CERTIFICATE OF APPROPRIATENESS

Property: 715 Bayland Ave, Lot 13, Block 34, Woodland Heights Subdivision. The property includes a historic 1,870 square foot, two-story wood frame single-family residence and a detached garage situated on a 5,000 square foot (50' x 100') interior lot.

Proposal: Alteration – Porch

Recommendation: Denial - does not satisfy criteria

SOUTH ELEVATION – FRONT FACING BAYLAND AVENUE

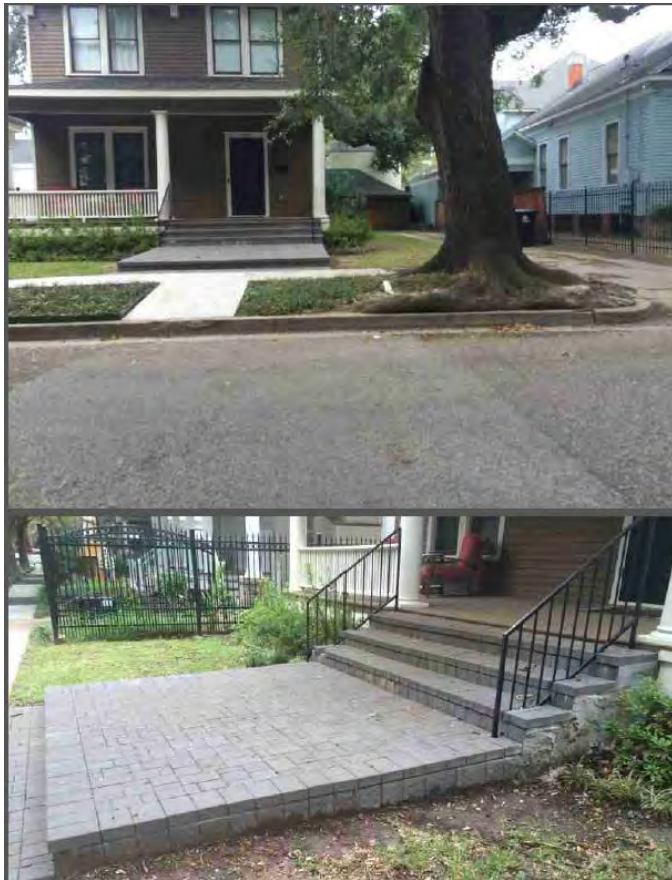
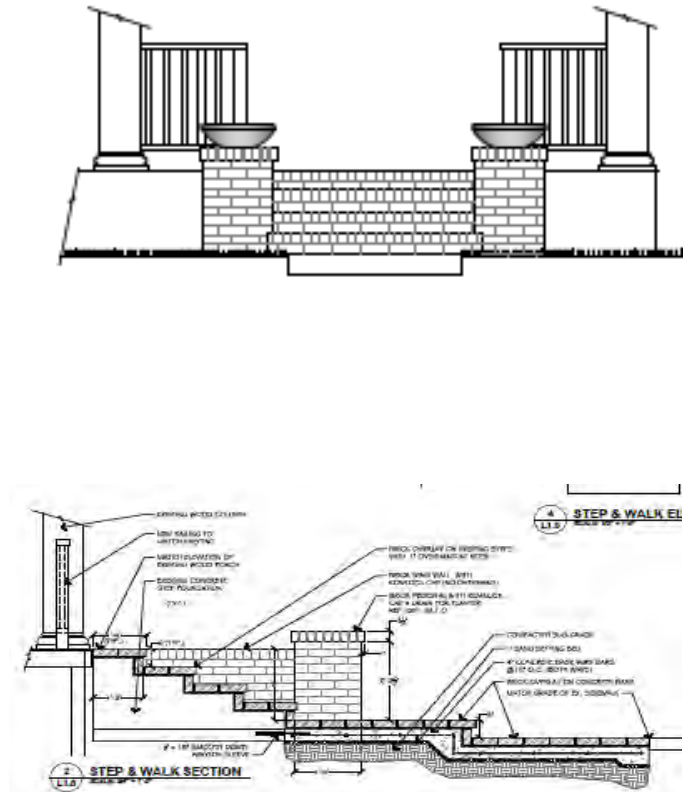
<i>The existing steps are approximately 10' wide and span the eastern half of the porch between the center column and east column. The change in step width as well as the change in materials from concrete to brick does not preserve the historical character of the property. The brick wing walls and pedestals are also not in keeping with the character of the house. An appropriate option for replacing the existing steps would be to install wood steps to match the existing width.</i> |

<i>The existing step width is an established characteristic of the residence. The addition of brick cladding, wing walls and pedestals has not been supported by physical or pictorial evidence and creates a false sense of history.</i> |

<i>The existing step width is an established characteristic of the residence. The change in step width, the introduction of brick, and the wing walls and pedestals do not preserve the distinguishing entrance onto the porch and residence.</i> |

<i>Brick steps are not a typical original feature of contributing structures within the district. Concrete or wood steps are appropriate materials for entry steps. If the applicant wishes to remove the existing concrete, wood steps of the same dimensions as existing are an acceptable alternative.</i> |
